1 Products affected

Change Notice					PCN UMx 250 - Added Meti approval		
owner	creation date	release date	released by	change order	rev	page	D10-069-916
bianchro	04.01.2023	04.01.2023	schulejo	2025268	B	1 of 2

Current product approval	New product approval
No PSE - JET	PSE - JET
Current product appearance	New product appearance

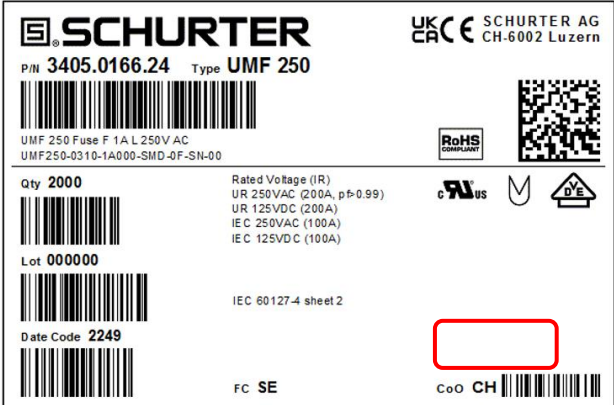
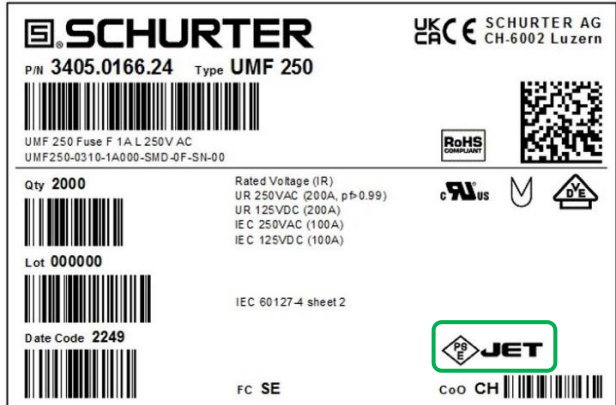
- Change of approval markings and packaging labels adding PSE - JET. This change has no effect on the validity of the approval certificates.
- The Meti Approval from the Japan Electrical Safety & Environment technology Laboratories (JET) with number JET 2245-31007-2006 applies for the whole UMx 250 family. The PSE-JET logo appears on the fuses and packaging labels.
